# ADDENDUM # 1

JOB #: 12-225

DATE: 1/3/13

PROJECT: DPW #13720, IDVS: Replace HVAC Controls System, VETB

M3.1 R1

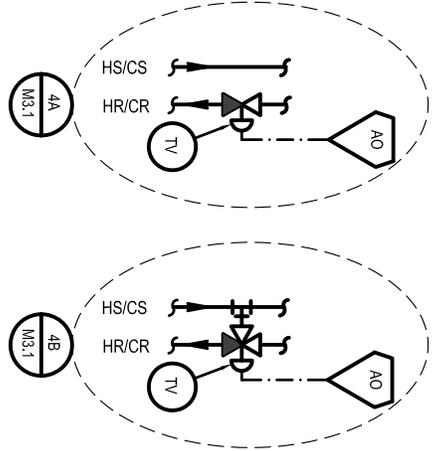
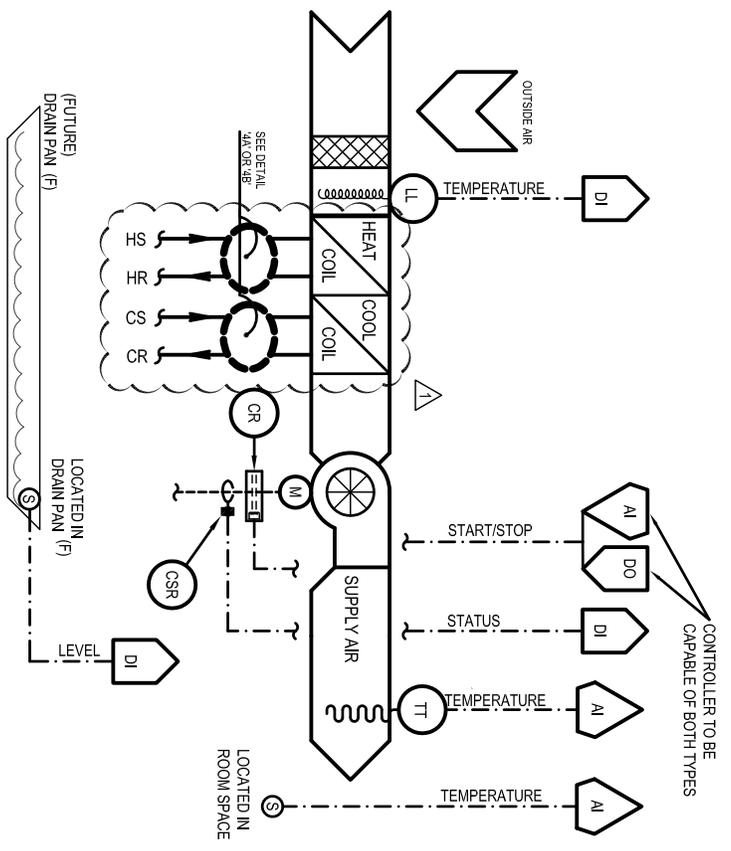
1. Sheet M1.1, Sheet M3.1 (Fan Coil Control System Schematic), and Sheet M4.1 (Control Valve Schedules) – This system is a 4 pipe system. Each fan coil having valves replaced will require 2 control valves, one for heating and one for cooling. The floor plans, schematic, and schedules show a single valve for each fan coil. Two are required. See attached drawing, M3.1 R1.

SHEET NO.  
M3.2 R1

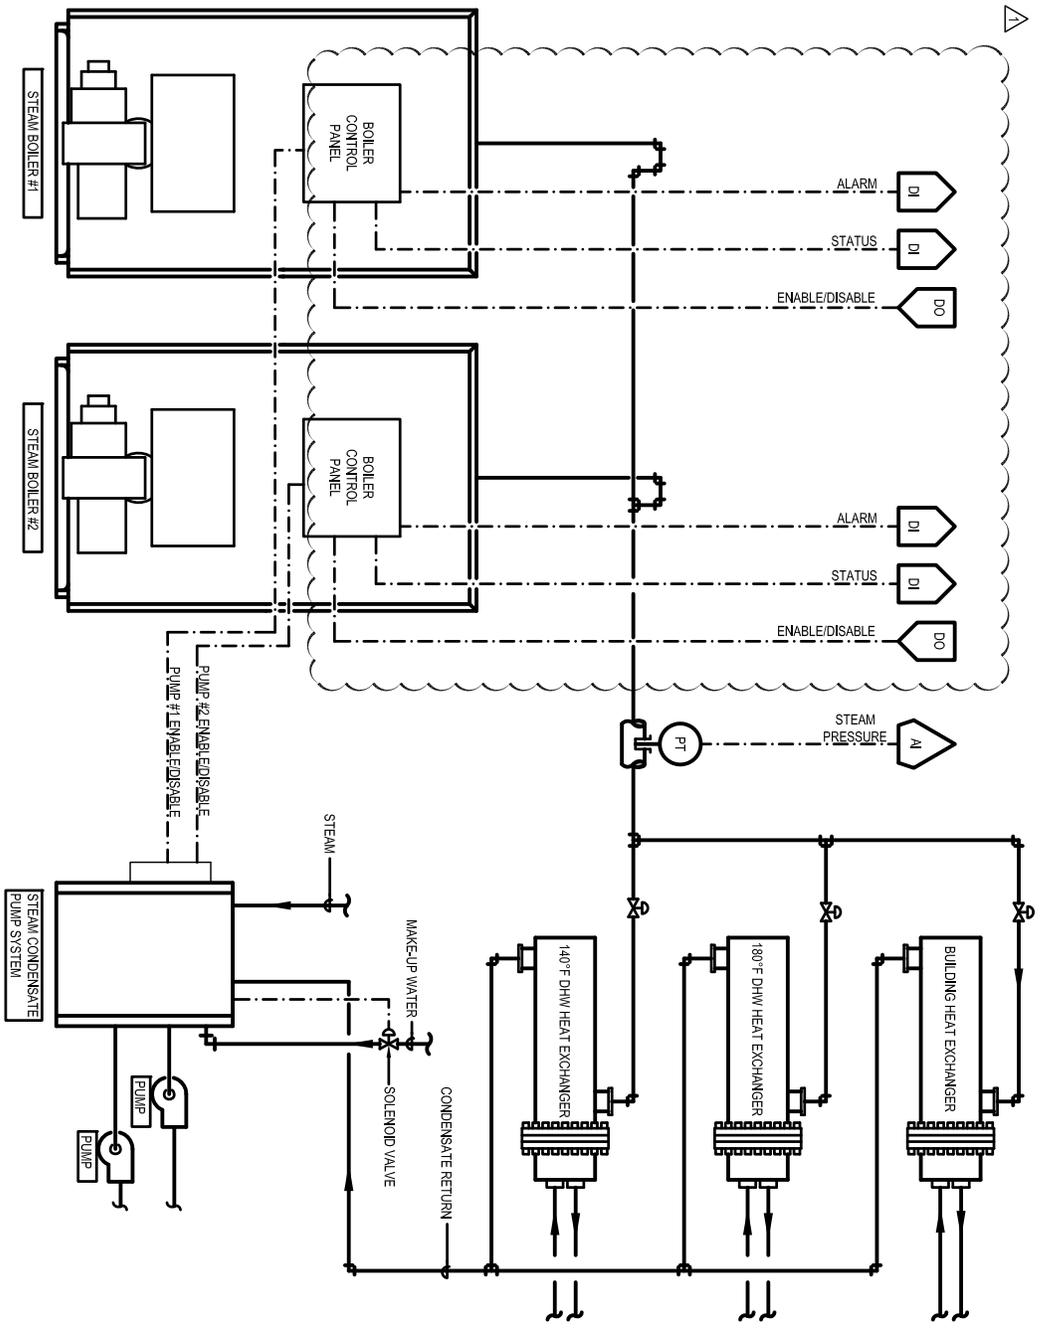
3. Sheet M3.2 (Steam Boiler Control Schematic) -- Additional points should be added to each boiler, DI-status and DO-enable. See attached drawing, M3.2 R1.
